DOCUMENT 009113.02 – ADDENDA 02

- A. Project Name: Grove Pond Water Treatment Plant (WTP) PFAS Treatment Facilities.
- B. Owner: Town of Ayer, Massachusetts.
- C. Owner Project Number: 19DPW08.
- D. Engineer: CDM Smith Alan G. LeBlanc, P.E., BCEE.
- E. Date of Addendum: May 20, 2019.

DATE: MAY 17, 2019		ADDENDUM NO.	FIGURE NO.
SHEET NO.	LOCATION	2	SK-A-2
A-7	E

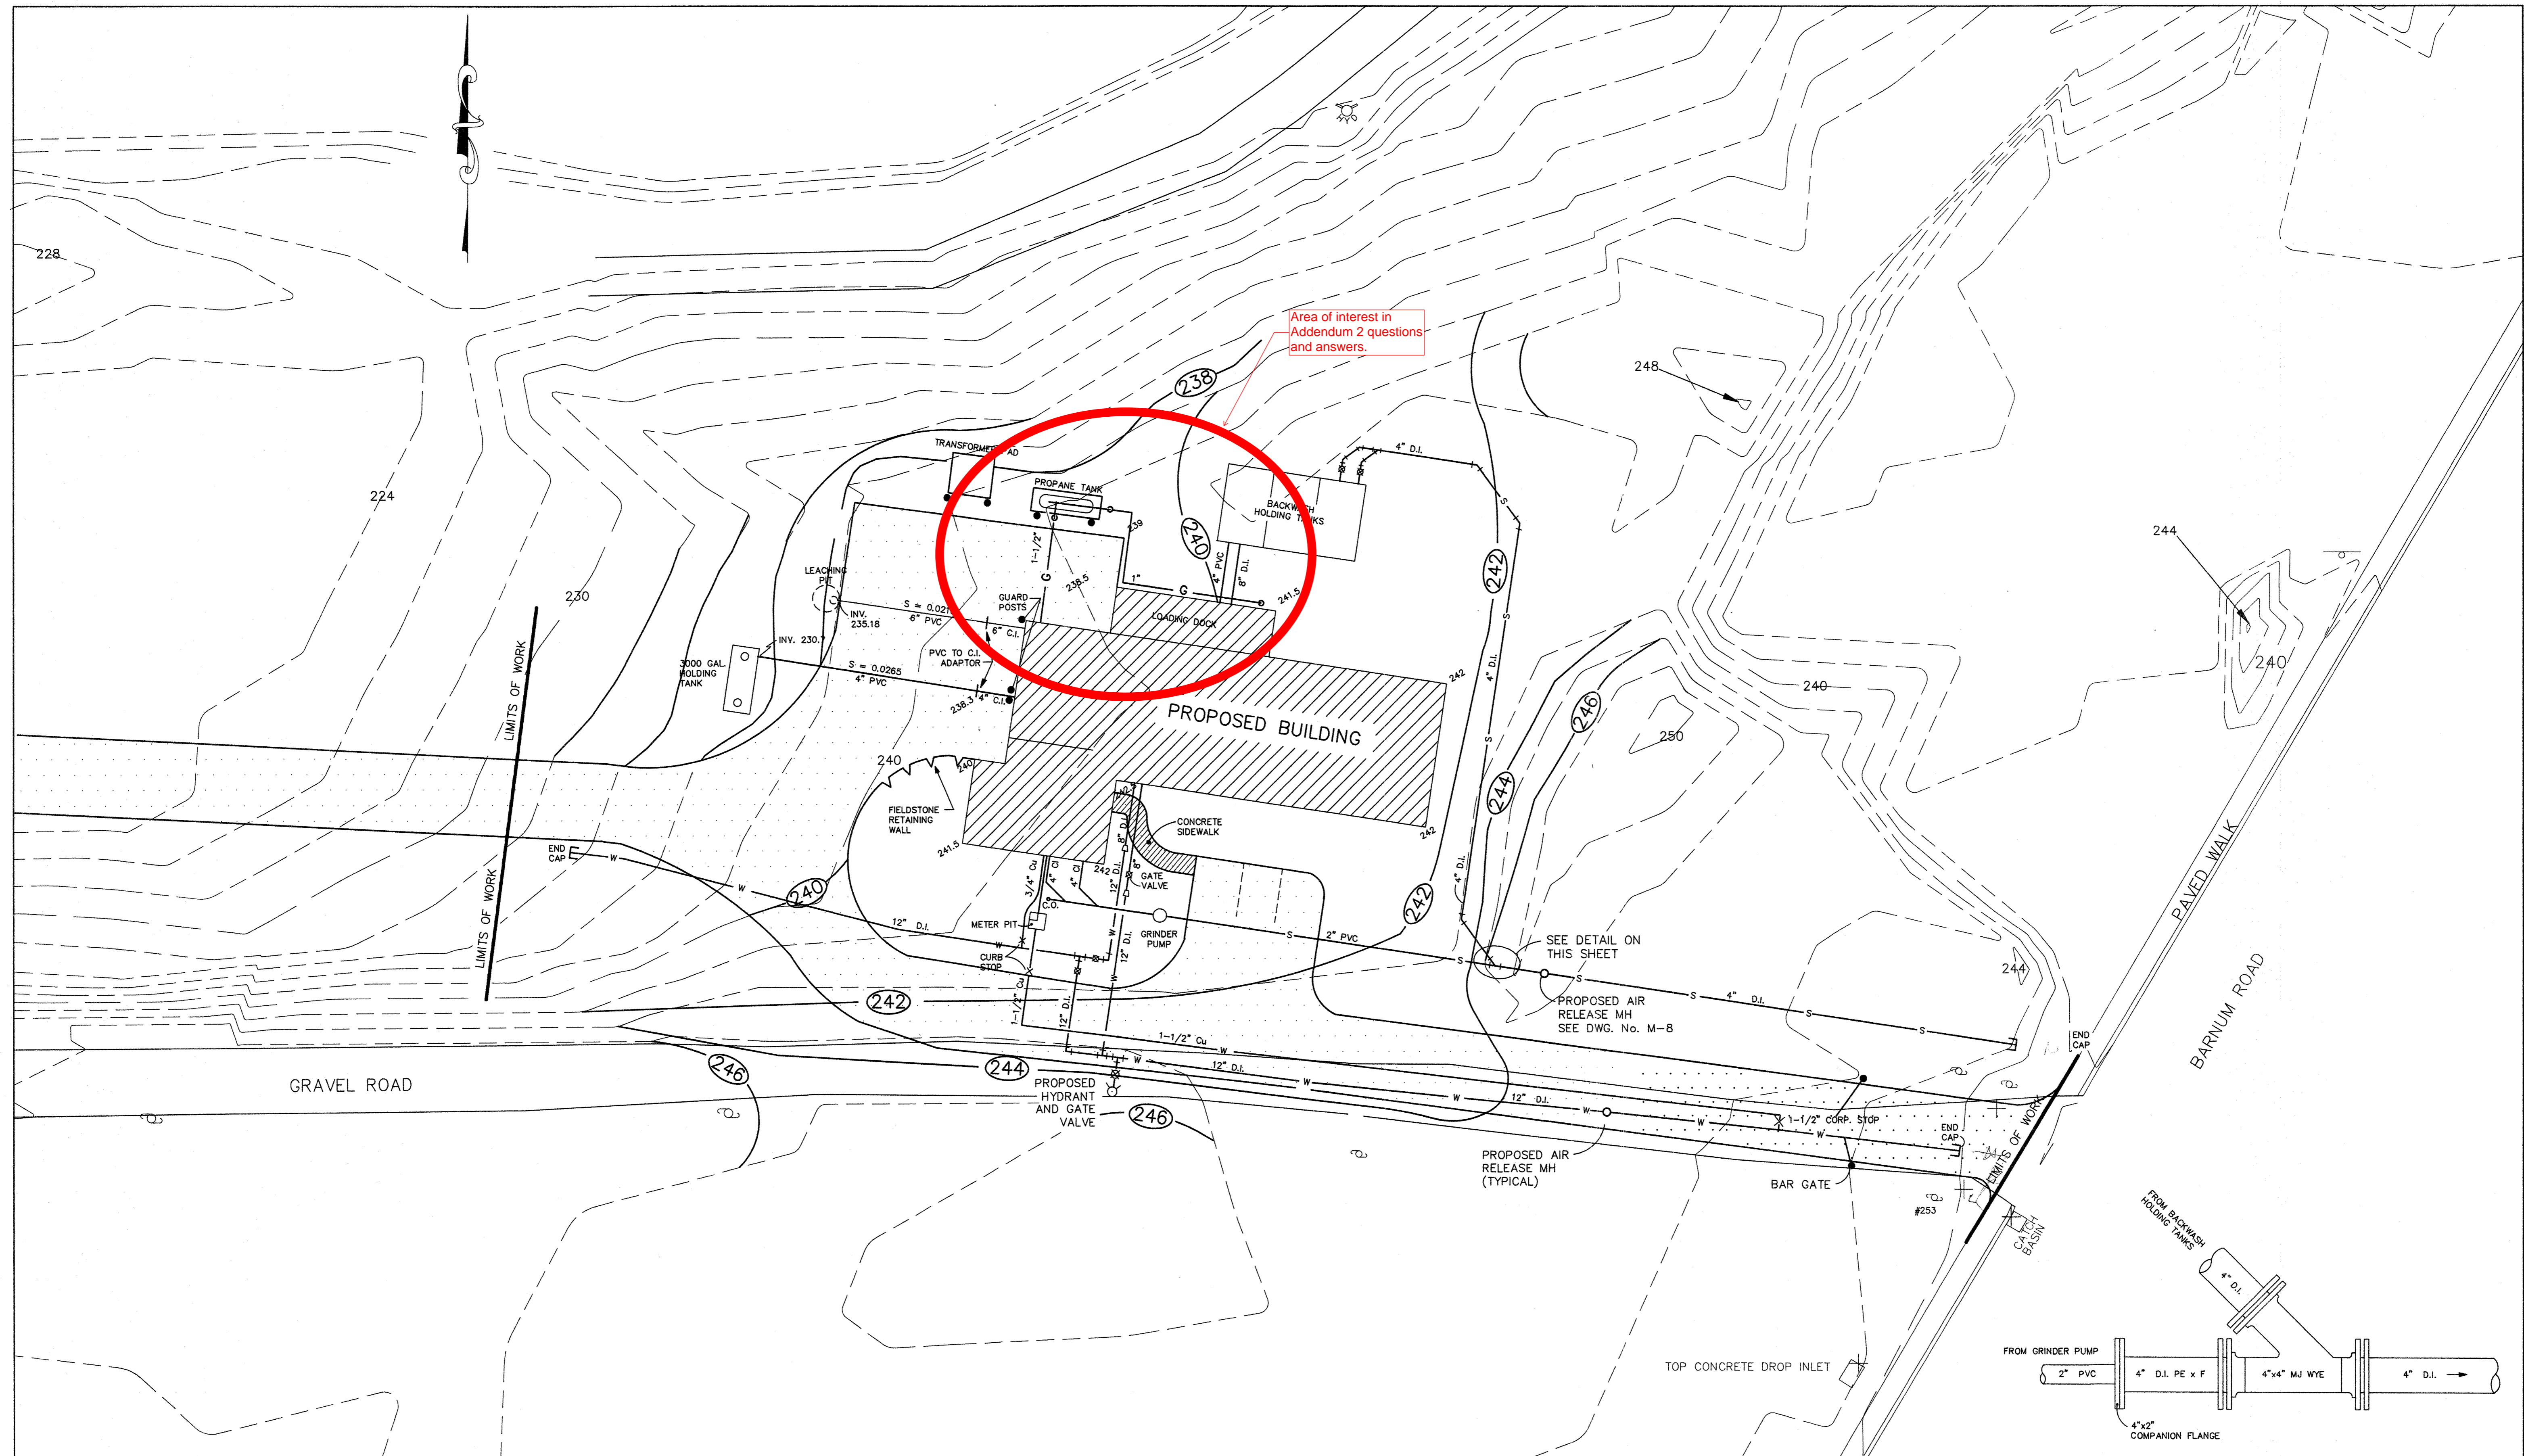
- A. Sheet No. A-6 – Section 3 (not reissued). Refer to SK-A-2, attached, for material modifications associated with revised detail E/A-7.
- B. Sheet No. A-7 – Details I (not reissued).
  - 1. Detail E: Replace Detail E with the attached SK-A-2.
  - 2. Add a General Note to the Drawing as follows:

- D. **Question:** Detail E on Drawing A-7 is the only detail showing the new ballasted EPDM Roof. Please confirm the roofing contractor is to provide rigid insulation, vapor barrier, substrate/cover board and EPDM membrane for this system?

**Reply:** The extents of “New Ballasted Loose Laid EPDM” roofing and “Adhered White EPDM Roofing System (No Ballast),” are indicated on Sheet No. A-4. For the “ballasted” EPDM roofing system. See “ATTACHEMENTS”, “REVISIONS TO DRAWING SHEETS”, and “REVISIONS TO DIVISIONS 02 - 49 SPECIFICATION SECTIONS.”

DWG. NO.  
**G-1**

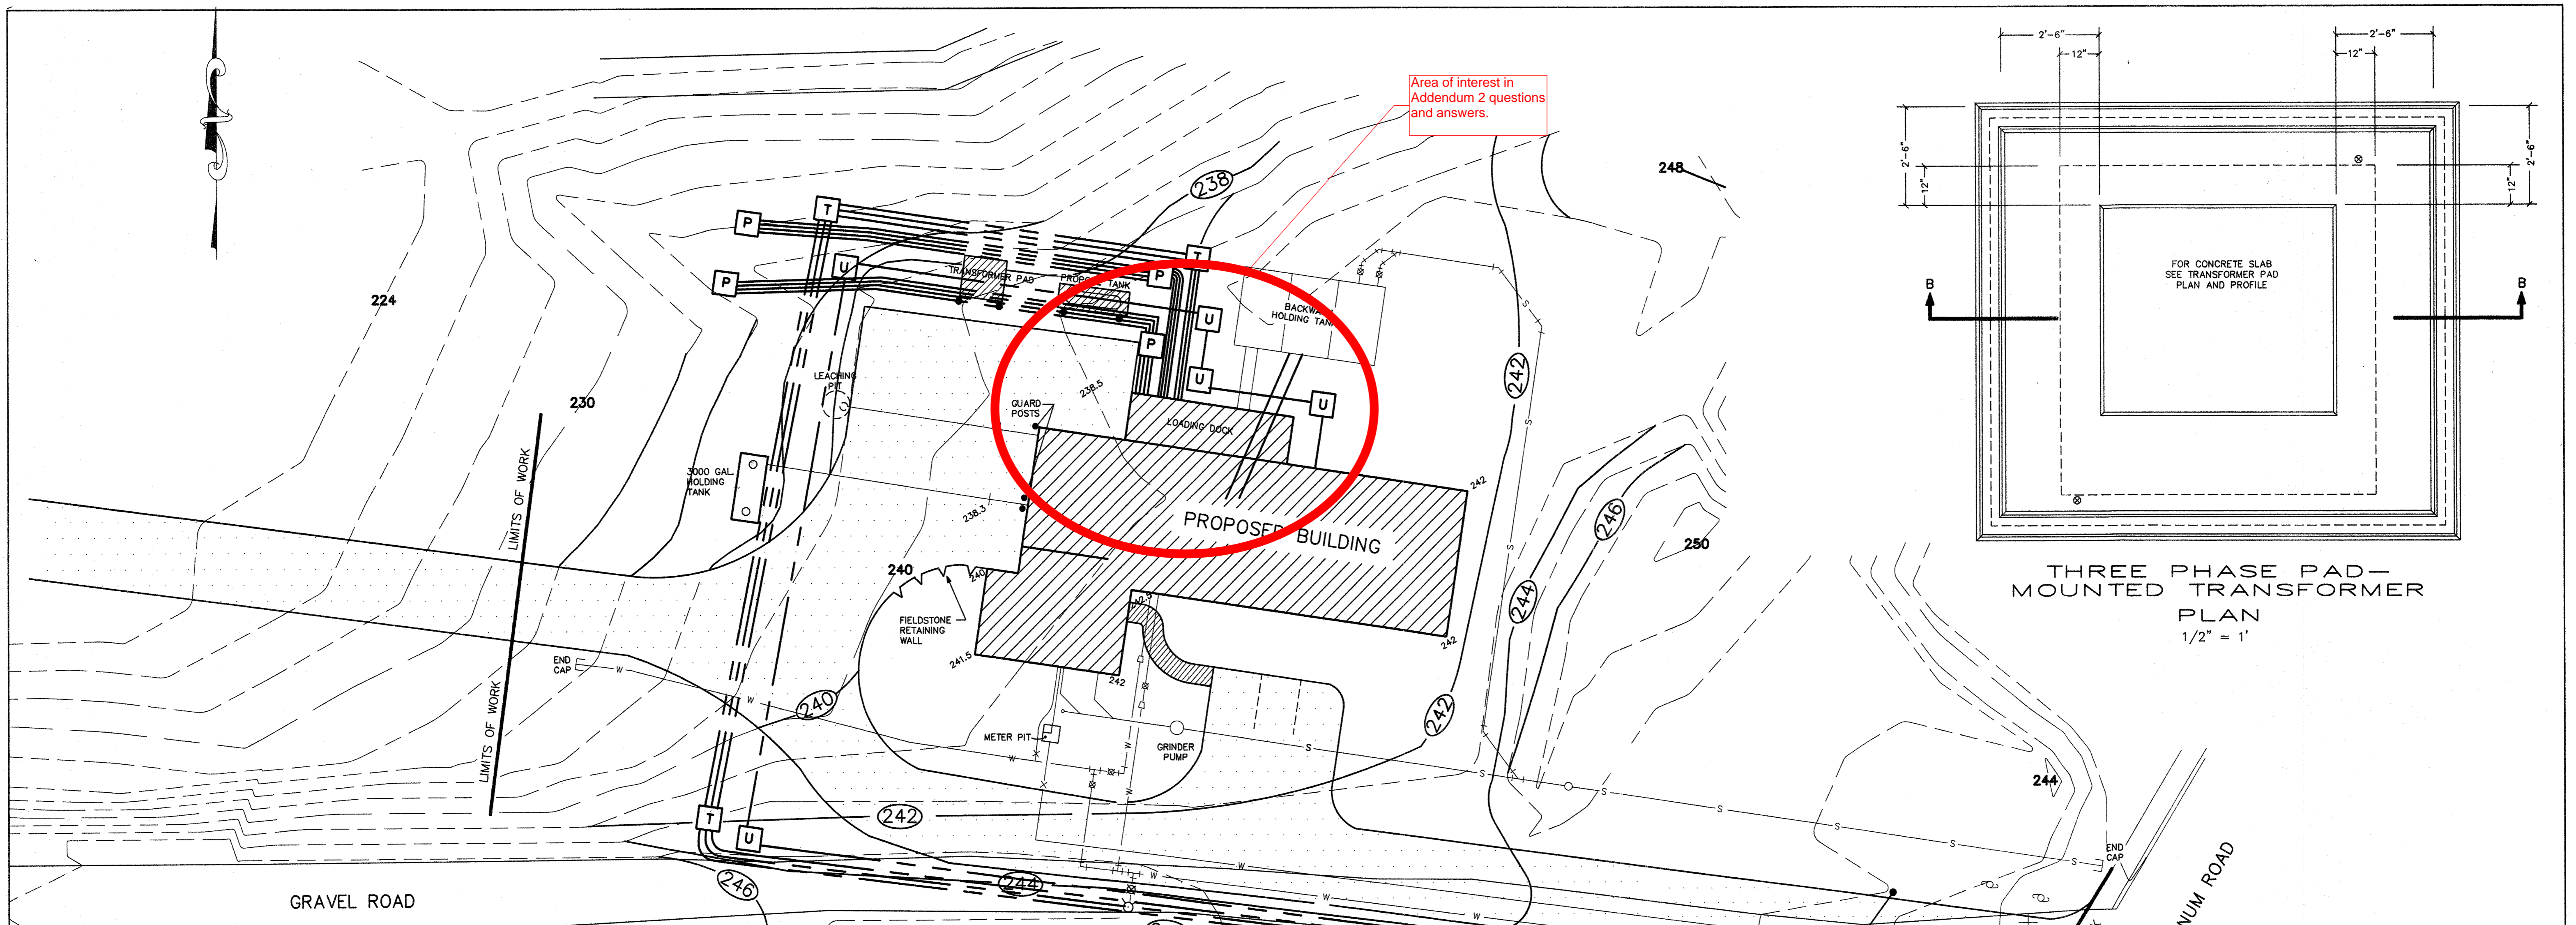
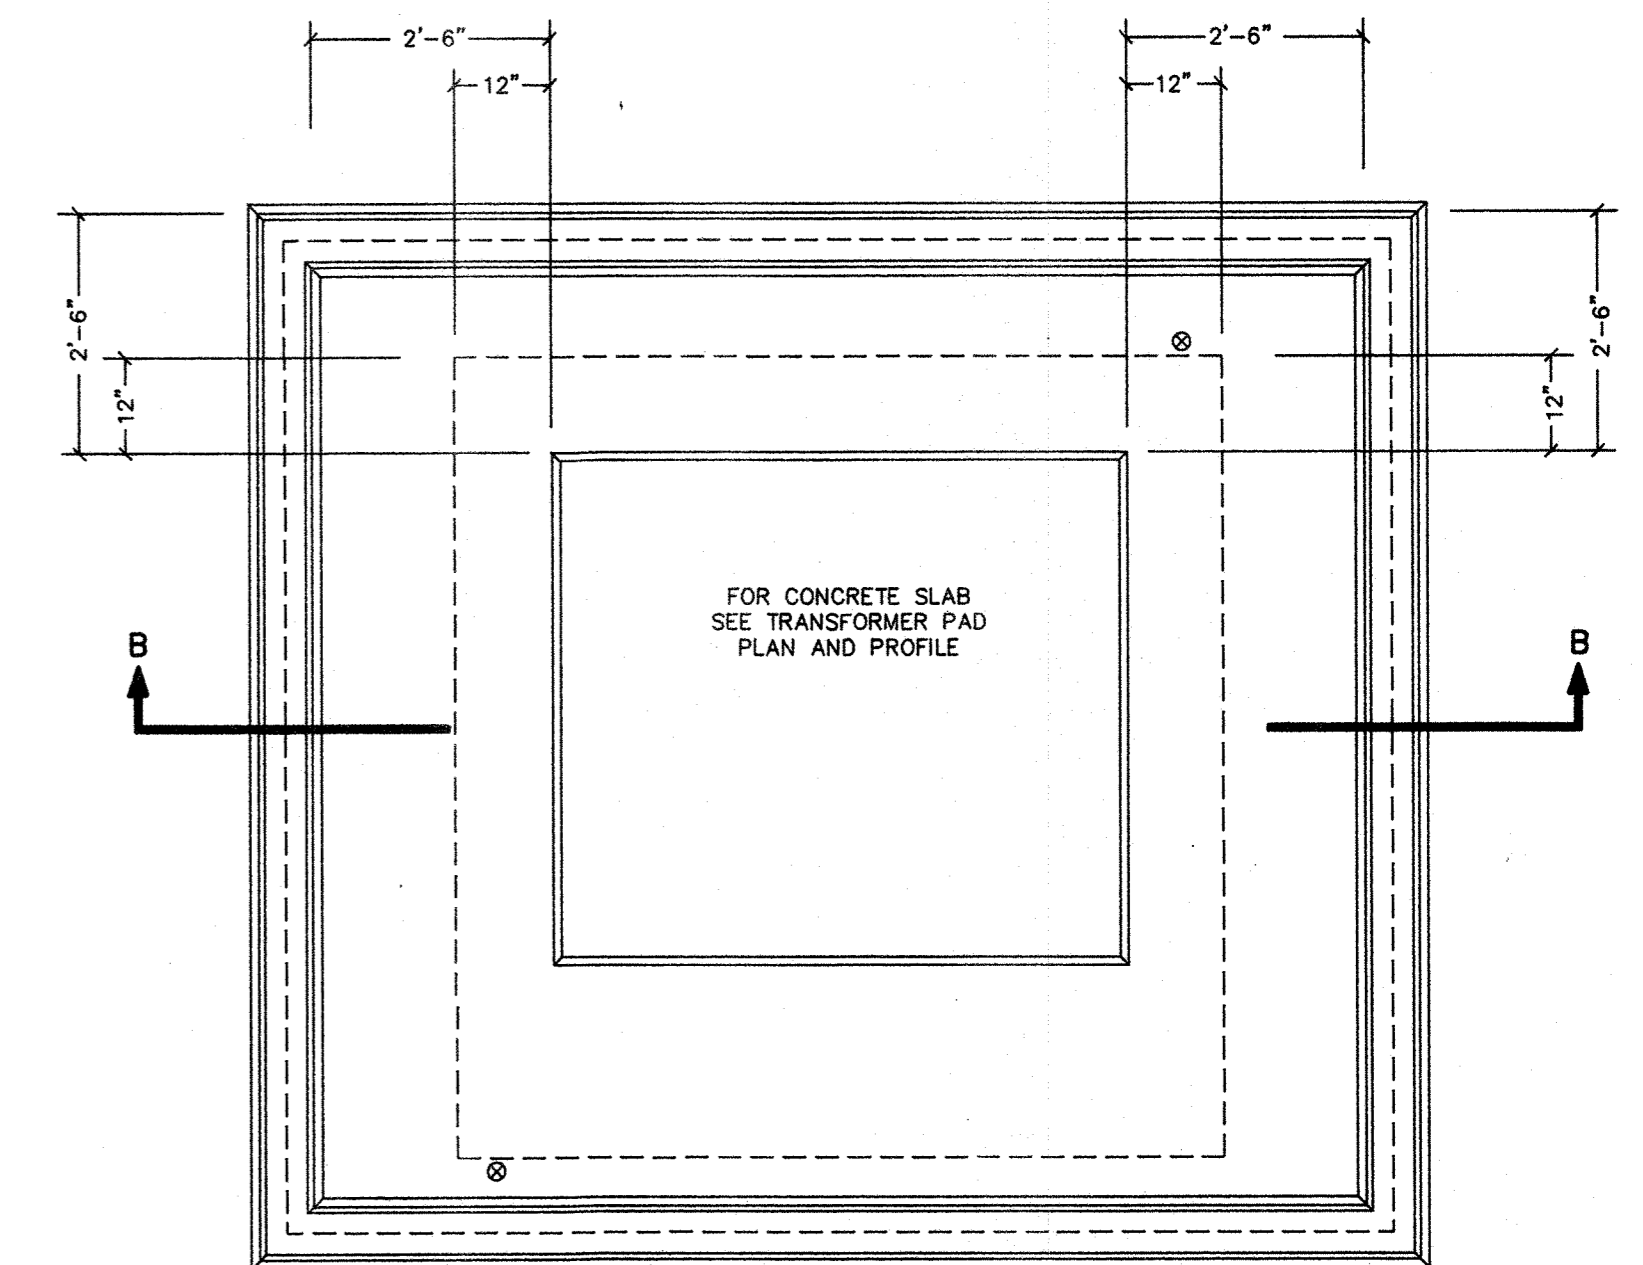
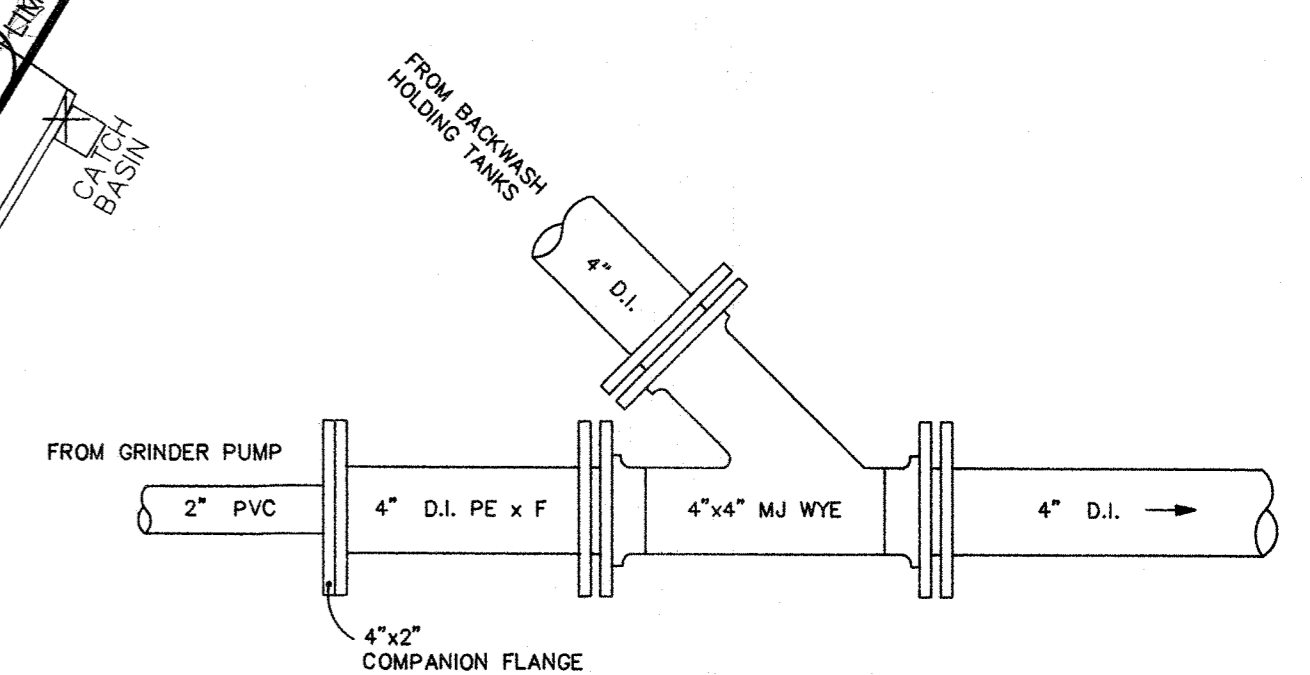
- G. **Question:** Drawing C-5 indicates existing process piping, propane gas, and buried electrical immediately west of the proposed AIX Effluent piping. Can you clarify what buried utilities exist in that vicinity?

**Reply:** Please refer to attached Document 2, which is a copy of Drawing G-1 by Haley and Ward, last revised 4/11/1996 and Document 3, which is a copy of Drawing E-7 by Haley and Ward, last revised 4/12/1996. Engineer makes no warranty that Document 2 and Document 3 are accurate at present, but the documents are provided as the best available information for bidding and construction planning purposes.
